**TOWN OF LEESBURG  
NOTICE OF PUBLIC HEARING  
TO CONSIDER REZONING APPLICATION TLZM-2012-0003  
CRESCENT PLACE  
REZONING AND CONCEPT PLAN & PROFFER AMENDMENTS**

**TOWN OF LEESBURG  
TOWN COUNCIL PUBLIC HEARING STAFF REPORT**

**SUBJECT:** TLZM-2012-0003, Crescent Place a concept plan and proffer amendment and rezoning application.

**TOWN OF LEESBURG  
PLANNING COMMISSION PUBLIC HEARING STAFF REPORT**

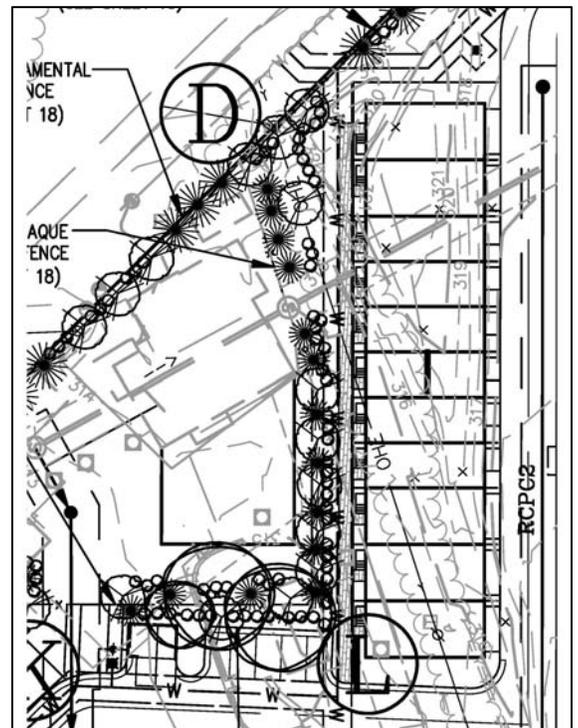
D-L, Adjacent to AT&T: It is the opinion of Staff that the placement of residential dwelling units to within 35 feet of a utility facility that requires noise attenuation does not meet the standards required for approval of a PD District. Regardless of the decibel achieved with attenuation, one can speculate that noise could be a concern for future home owners. This potential issue is one where Staff is not comfortable creating a condition which could preclude the reasonable use and expectation of a residential property owner.

Required buffering and screening are requested to be modified in an effort to maximize a suburban style dwelling unit density. The required buffer-yard of a utility use adjacent to a residential use is 75 feet. The provided buffer-yard is only five feet in width and not suitable for the three components of the required screening material: shrubs, evergreen trees and canopy trees.

The Applicant is requesting significant reductions in buffer-yards to maximize the yield of a suburban styled development pattern. The buffer-yard surrounding this public utility building is reduced from 75-feet to 5-feet, with the closest residential buildings located 20-feet from the property line. The utility building generates a noise that must be attenuated. The Applicant has proffered and must satisfy TLZO requirements for noise. While noise attenuation can be achieved, the proximity of the dwelling unit and the noise that will still be generated is not appropriate in the environment created by this development, in the opinion of Staff. The buffer

is needed to help allow the noise to dissipate and minimize the impact on surrounding residents. Absent an opportunity to allow the noise to disperse, the close proximity of Building I to the AT&T building will create a negative acoustical effect by echoing the noise. In addition, the units will face giant louvers screening the cooling apparatus of the utility. A buffer providing additional space for plants to grow will better screen the utility building from the proposed residences.

Based on the concerns stated throughout this report Staff does not support the modification of this buffer-yard. The site design in this area must be revised to provide an appropriately designed buffer-yard with screening material to mitigate the impacts on the units proposed within as little as 25 feet of the utility use.

Figure 1. Planned Land Use

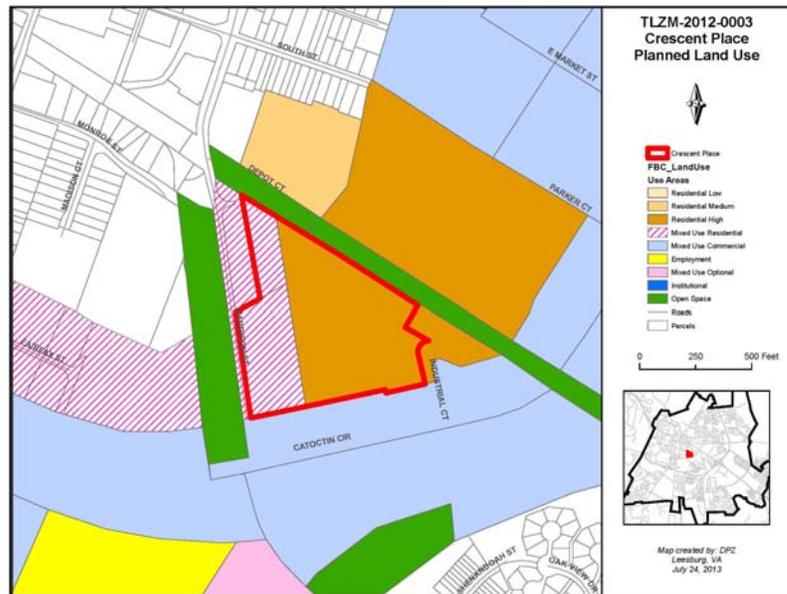
2. **Land Use – Mix of Uses.** The property is subject to the Crescent District Master Plan. The Crescent District Land Use Policy Map (Figure 1) designates two land uses on the property: Mixed Use along the frontage of Harrison Street and Residential uses for the interior of the property. The proposed density is approximately 19 dwelling units per acre (11.77 acres ÷ 226 units = 19.2). Note that the approved density on the site per Harrison Park proffers is approximately 28.5 dwelling units per acre. The application fits these designated land uses with the exception of the amount and location of

mixed use along the Harrison Street frontage. Where the Applicant owns property directly adjacent to Harrison Street, commercial use is not proposed. Instead, 2 over 2 townhouses are depicted. The reason for placing retail or office on Harrison Street is to extend the pattern of the traditional downtown as recommended in the Town Plan. Of the area on the Property designated for mixed use on the Land Use Policy Map, only forty percent (40%) is provided.

Staff recommends that a greater percentage of mixed use be provided along Harrison Street in accordance with the Land Use Policy Map. Applicant has responded “Although the proposed mix does not match exactly the percentages in the Plan, the applicant is proposing a mix that will work in the marketplace. This factor is critical since redevelopment in the near term is critical to kick starting implementation of the Crescent District Plans” (Response Letter dated June 14, 2013). Staff is not persuaded that disregarding the plan mix on this site will lead to greater adherence to the Plan on other sites in the Crescent District. Nor is the claim that the current market supports townhouses and 2 over 2 units as justification for eliminating ground-floor commercial along Harrison Street. The Applicant’s justification that it is not possible to develop the property under the Town Plan land use classification with the current economy, if accepted, makes it difficult to retain many of the CDMP policies, and this same claim can be made for other properties within the Crescent District.

Figure 2. Future Streets Policy Map

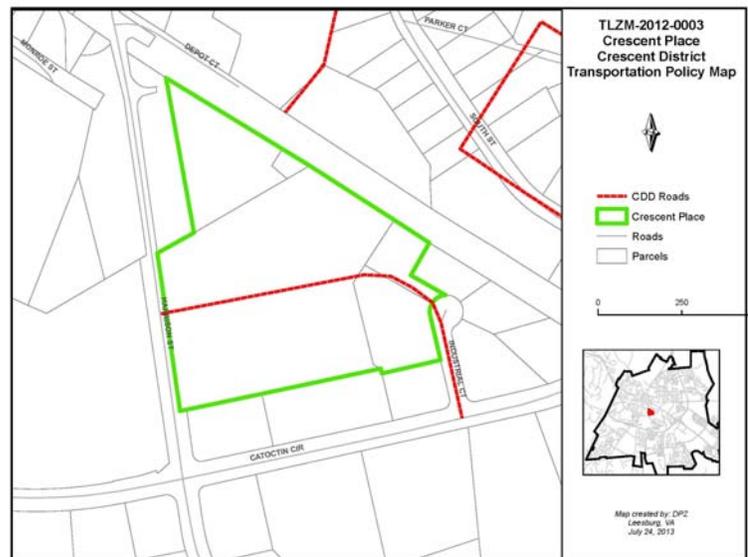
4. **Transportation.** The Crescent District Future Streets Policy Map (Figure 2) indicates a future public road through the site connecting Harrison Street to Industrial Court.

The intent of the CDMP is to create a grid of streets that will provide relief to traffic circulating through the Crescent District. The Applicant intends to satisfy the planned roadway with a private boulevard and connecting private streets, including two connections from the site to Industrial Court. While not a preferred solution, interconnectivity is provided. Given the residential nature of the interior of the development through which this road passes, and given the high unlikelihood of any vehicular crossing of the W&OD Trail, Staff agrees that a public road is not necessary or feasible in this location and that a private road will still provide a reasonable outlet for expected cross-through traffic.

Figure 5. Central Plaza

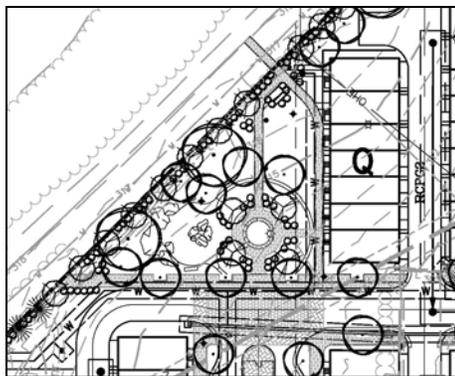
- b. Reduced Buffer Yards Amount to Half of Open Space:** Nearly half of the required open space is provided through narrow buffer-yards. In this particular case the required buffer-yards have been reduced to the extent that the resulting environment makes it challenging to place a well-designed screen (see Modification Requests in Section IV below). Most of the provided buffer-yards are approximately fifteen feet (15’) wide or less which makes it extremely difficult to provide any design other than a single-row-of-trees. Compounding this issue is the location of proposed underground utilities and the amount of proposed hardscape which will limit where buffers can be provided. The result is that the proposed buffer yards reduce minimum zoning requirements but do not function as a

complimentary design element for an urban planned community. Staff does believe that modifications to the standard buffer-yards are appropriate and necessary to achieve an urban design. However, the resulting widths and utility conflicts should be resolved to accommodate a well-designed screening scheme which complements both the proposed and existing development. Staff does not believe that the small strips of land provided make meaningful contributions to the design of the development, nor should they be interpreted to comprise the usable open space that is planned for this or any other infill project.

**Figure 7. Linear Pocket Park**

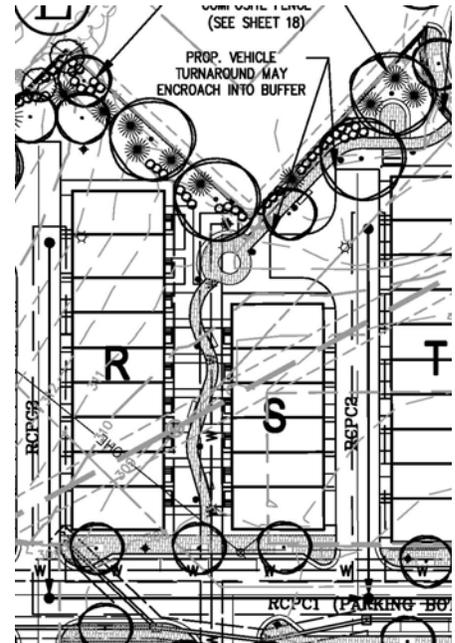
- The distance between the Buildings S and R stoops is approximately 20 feet and the area functions as the walkway to the front of the buildings.
- There is no landscaping proposed within this area
- A water line is collocated in this area.
- The proposed “gathering area” is still located less than 20-feet from the closest units

It is the opinion of Staff that this area is insufficient to be labeled “open space” as intended for infill situations due to the characteristics listed above.

Figure 10. Open space Linkage

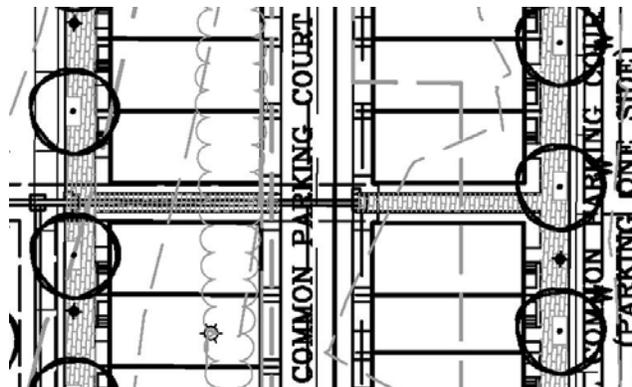
3. **Linkages:** Gaps between buildings are opportunities to provide meaningful linkages that are pedestrian scaled. Figure 10 depicts one such opportunity area. This sidewalk links the boulevard and the area identified as the common green. As designed, the gap between buildings is only 10 feet wide. Staff notes that adjacent buildings can be as tall as 50 feet; and due to the narrow

width there is little opportunity for lighting or landscaping. See Figure 11 for an illustrative example of the built condition. Staff recommends minor changes in the layout as illustrated in Section VII of this report.

Figure 12. Dumpster Location

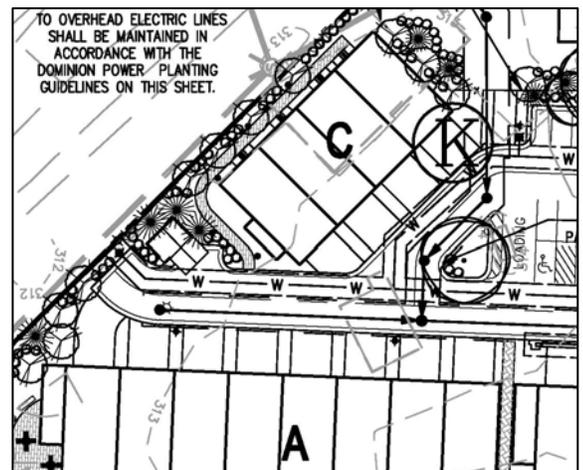
4. **Dumpster Location:** Although the Applicant has proffered to incorporate a compacting solid waste container, Staff is not certain this mitigation measure is adequate. The main access to the front doors of the adjacent residential units is still past the dumpster location (see Figure 12). Staff is also concerned that the potential odor from commercial solid waste, possibly including food waste, has not been successfully mitigated.

Figure 14. Enhanced Linkage

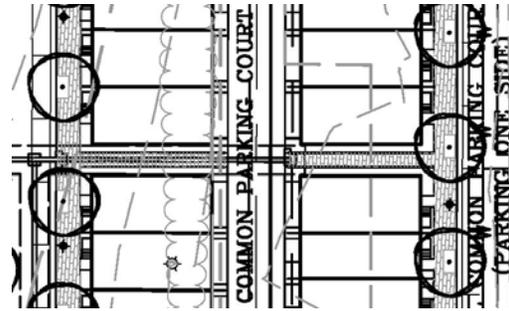
- a. **Enhanced Linkages:** Without losing any units, wider and more inviting pedestrian-scale linkages between open space amenities can be accommodated. For instance, adjusting buildings M, N, O, P such that the end units are 20-feet wide, with 16' wide interior units (a unit type proposed by the Applicant) a wider area can be provided. The area in question would increase from approximately nine-feet to approximately 22 feet, which provides room for sidewalk, landscaping and safety lighting (see Figure 14 below).
